CENTERVILLE CITY PLANNING COMMISSION AGENDA

**STAFF REPORT
AGENDA: ITEM 1**

**STAFF REPORT
AGENDA: ITEM 2**

CENTERVILLE CITY DECANT STATION

- ▢ 01-08-20 PC Staff Report - Dave's Auto Landscaping Waiver
- ▢ Site Plan
- ▢ Landscaping Plan

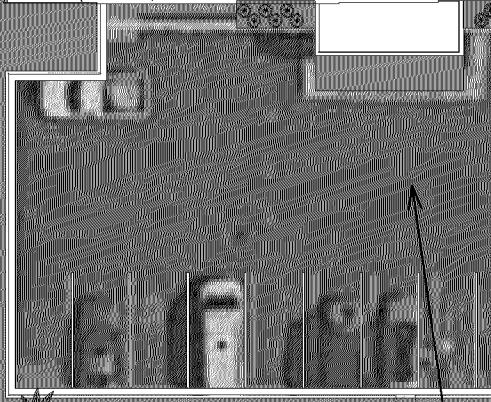
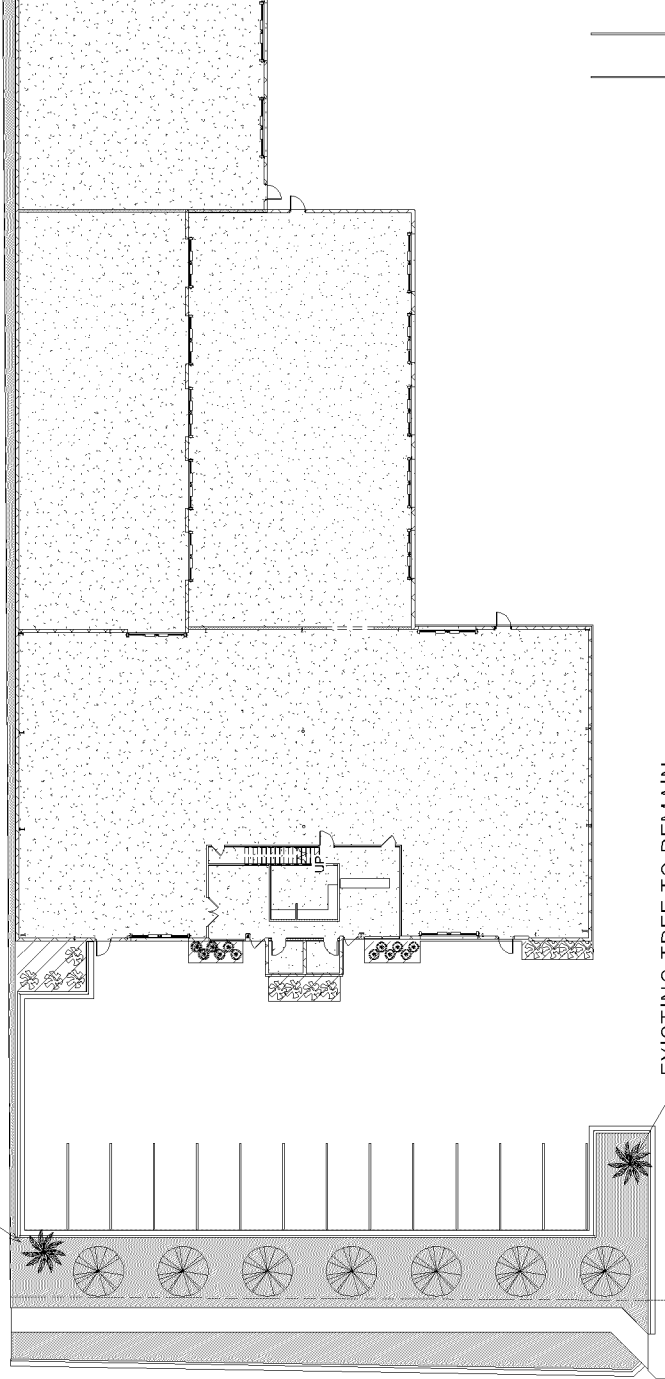
Required Landscaping Summary CZC 12.51 – 56,523 square feet			
Guidelines	Standard	Proposed	Compliance
Total Area Landscaping	15%	6.4%	NO
Total Required Trees	1 Tree per 500 square feet of <i>required</i> landscaping	7 shown overall (22 Trees Required)	NO
Trees for Street Frontage	1 per 25 linear feet	7 (7 Trees Required)	YES
Building Frontage Foundation along Public Street	50%	% not provided	NO
Total Interior Parking Lot Landscaping	7%	0%	NO
	For every six <i>required</i> stalls: 1 tree	TBD (see Request for Parking Modification)	TBD
	For every six <i>required</i> stalls: 2 shrubs	TBD (see Request for Parking Modification)	
Buffer Landscaping Between Residential and Non-residential Development	30 feet	0 feet	NO
Landscape Architectural Approval	All Sites 1 acre or Larger	1.29 acres – missing required approval	NO
Utility Screening	Must be screened from Public Street View	None (see utility area front north side)	NO

Architectural Buffer	At least 6 feet in height	8 feet CMU wall	YES
Buffer Trees	For every 20 feet of fencing: 1 evergreen tree	0 (13 required)	NO

Landscaping/open space is required to be 15% of the project area. This equates to about 10,873 square feet of landscaping for this property. The proposed plan provides approximately 6.4% of landscaped area. The frontage area requires seven (7) trees, and the proposed plan includes seven trees. The applicant has proposed building foundation landscaping along the Frontage Road façade. The on-site landscaping and required trees is to be determined when the applicant's parking modification request is addressed by the Planning Commission. The current plan indicates no on-site landscaping. Lastly, the landscaped buffer area adjacent to residential area is to include thirteen (13) trees and the applicant requests no trees.

The architectural feature (30-foot buffer) requires the use of perimeter fencing along the south and east property lines. The proposed plan indicates that the existing fencing is to remain in these two areas.

Staff Conclusion – The applicant has committed to maintain the eight-foot CMU wall as a buffer to the residential zones adjacent to the property. However, staff finds that eliminating the buffer does not preserve the intent of the Chapter. The Chapter specifically calls out evergreen trees and shrubs to provide “a visual and noise reducing barrier.” Staff recommends reducing the buffer, but maintaining the tree requirement put forth in 12.51.070(b)(1)(a). One evergreen tree for every linear 20 feet of buffer needed to preserve the intent to buffer the C-VH land use from the adjacent residential property. Staff recommends reducing the buffer to the Commercial Medium/Residential buffer requirement of fifteen feet.

Staff Conclusion – Eliminating the buffer would adversely affect the residential properties. While a change would not currently alter conditions to the neighbors, an increase in business and noise would alter the neighborhood. In addition, the property to the east is zoned Residential Medium and if it is developed having no visual or noise barrier would affect the property. A reduction in the required buffer size could create the barrier while also minimizing the affect the buffer would have on the circulation of the applicant property parking.

Staff Conclusion – It is the opinion of staff that upgrading the site to install the 30-foot buffer creates problems that would not be resolvable, specifically with site circulation. If the buffer was installed it would eliminate the east parking area. Furthermore, this site has three residential boundaries located to the south and east. A 30-foot buffer along these three boundaries would substantially affect the ability for developing the site. However, staff recommends a 15-foot buffer to maintain the intent of the Chapter. Therefore, the waiver of strict compliance for the required 30-foot buffer, in this particular case, appears to be appropriate.

1. This waiver shall be limited to 30-foot landscaping buffer.
2. The existing eight-foot screening wall shall be maintained along the south and east property boundaries adjacent to the residential zone.
3. The Zoning Ordinance requirement thirteen (13) trees shall remain in effect and the trees shall be depicted and installed as part of a final site plan approval.
4. A buffer of fifteen (15) shall be provided along the Residential zone.

- ▢ 01-08-20 Staff Report Conceptual Site Plan Centerville Decant Station
- ▢ Centerville City Decant Station Conceptual Site Plan Submittal

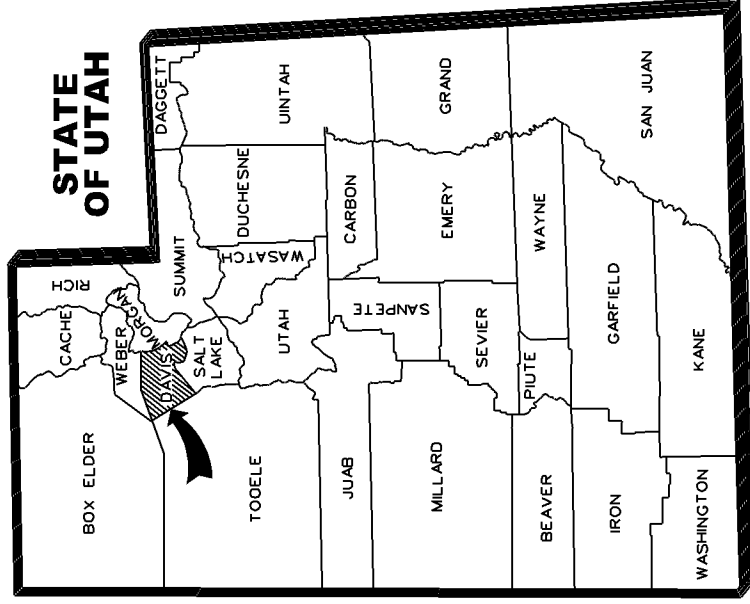
Table 12.33.1 – Base Zone Development Standards <i>(Public Facilities – Very High (PF-VH) Zone)</i>			
Development Standards	Required	Actual	Compliance
Building Standards			
Distance Between Buildings	6 Feet	Not provided – <i>Located near the UTOPIA Hub Building</i>	Likely
Maximum Height	35 Feet for Accessory Buildings	28 Feet	Yes
Setbacks			
Front	25 Feet	Not Provided	Likely
Rear	1 Foot	Not Provided	Likely
Side Yard	10 feet	Not Provided	Likely
Floor Area per Building, Maximum	50,000 sq. ft.	1,612 sq. ft. <i>(both phases) *</i>	Yes

- ✓ Nonconformity, Other (CZC 12.22.080) - The current facility is considered compliant with the original approved amended site plan of August 2001, which added the Parks and Recreation Building to the facility. This approval occurred prior to the original 2003 adoption of the current Zoning Ordinance, as amended. Therefore, the development is deemed a legal nonconforming site. Due to this project being less than a 30% expansion of the existing facility (*just over 5%*), there are a few ordinance provisions that are considered "Not Applicable" or "Limited in Scope." Consequently, development regulations with regards to landscaping, screening, and parking, will not be addressed in this report, as they are exempted by the applicable nonconforming provisions.

- ✓ Signs (CZC 12-54) – The plans depict the proposed use of concrete tilt-up panels, which also depicts the use of wall signs displaying the City’s Logo. The proposed use of wall type signs is required to comply with CZC 12.54.110(b)(1).

- ✓ Adequate Public Facilities – The conceptual plan depicts all the typical utility service lines within the area. All utility providers will need to be notified in conjunction with the Final Site Plan application submittal. Any planned connections will need to be reviewed and approved by the applicable entity providing such service.
- ✓ Accessory Uses and Structures – The applicable expectation here is the proper discharge of storm water that will be generated from off the building. It appears that the siting of the building can comply with this standard.
- ✓ Outdoor Lighting – The plans do not depict the use of building lighting. If lighting is planned, the use of such will need to comply with CZC 12.55.140, regarding the shielding of all lighting fixtures.

- ✓ Structure Phasing - The concept plan depicts the entire footprint of the accessory structure. However, pending funding for the building, it may be constructed in two parts. One side (west) will be for the decant portion of the accessory use. The other side (east) will be for materials storage. The central wall will be reinforced to allow for front loader operation to scoop the materials into the loading bucket. The east area may consist of only a concrete pad until the funding is secured for the walls and roof. Nonetheless, the conceptual plan is requesting an approval for the entire building.
- ✓ Use of remaining underdeveloped area - Staff raises the concern with allowing the remaining area to be underdeveloped or left in a state of dirt, mud and weeds that can create air quality, stormwater management, or visual nuisance issues regarding the property.

1. *The applicant must submit a final site plan application in accordance with CZC12.21.100 of the City’s Zoning Ordinance.*

2. *The final site plan must address the following:*
 - a. *Depict the setbacks distances that meet the PF-VH Zone Standards*
 - b. *Send and collect, as part of the submittal, all related “utility provider” notice letters.*
 - c. *Address the use of signs on the building.*
 - d. *Report on the use of outdoor lighting.*
 - e. *Provide final plans for addressing storm water management and drainage*
3. *The Final Plan submittal must also address the concerns regarding the use and management of the remaining open land surrounding the proposed building to mitigate issues with air quality, stormwater management, or a visual nuisance of the property.”*
